# Access Compliance Report

## Public Rights-of-Way

Intersection ID: 13809	Main Street: CHESTERFIELD_AV	Cross Street: ST_JULIEN_ST	Location:	N
ADA ID: 682D84F433C2	Ramp Type: PerpDiag	Initial Pass/Fail: Fail	Overall Compliance: No	Severity Score: 12.5
Codes/Mitigation Info/Possible Solution		Field Measurements/Component Compliance

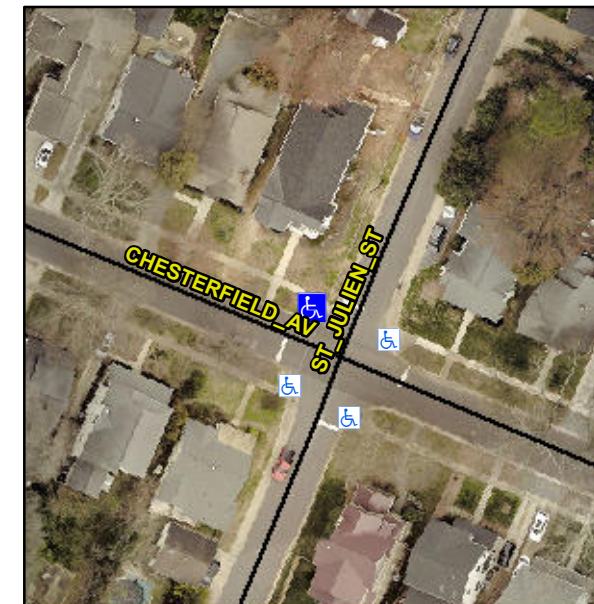
**Not Found, R304.2.2**

Compliance	Description	Data	Compliance	Description	Data
N/A	Ramp Length (in)	63.0	No	Ramp Slope (%)	8.6
Yes	Ramp Width (in)	50.0	Yes	Ramp XSlope (%)	1.1
N/A	Flare Type LT	N/A	N/A	Flare Type RT	N/A
N/A	Flare Slope LT (%)	N/A	N/A	Flare Slope RT (%)	N/A
N/A	Flare Traversable LT?	N/A	N/A	Flare Traversable RT?	N/A
N/A	Landing Length (in)	N/A	N/A	DWS Provided?	N/A
N/A	Landing Width (in)	N/A	N/A	DWS Contrast?	N/A
N/A	Landing Slope (%)	N/A	N/A	DWS Length (in)	N/A
N/A	Landing X Slope (%)	N/A	N/A	DWS Full Width?	N/A
N/A	Landing Curb? (Y/N)	N/A	N/A	DWS Offset (in)	N/A
N/A	Shared Landing?	N/A			
N/A	Gutter Ponding?	N/A	N/A	Gutter Slope (%)	N/A
N/A	Gutter Lip Ht (in)	0.5	N/A	Gutter X Slope (%)	N/A
N/A	Painted X Walk1?	No	N/A	Painted X Walk2?	No
	X Walk 1 Direction	To SW		X Walk 2 Direction	To SE
N/A	X Walk 1 Width (in)	N/A	N/A	X Walk 2 Width (in)	N/A
	X Walk 1 Slope (%)	5.5		X Walk 2 Slope (%)	0.9
	X Walk 1 X Slope (%)	1.9		X Walk 2 X Slope (%)	0.1

**Remove & Replace Curb Ramp With Two New Directional Ramps or Equivalent.**
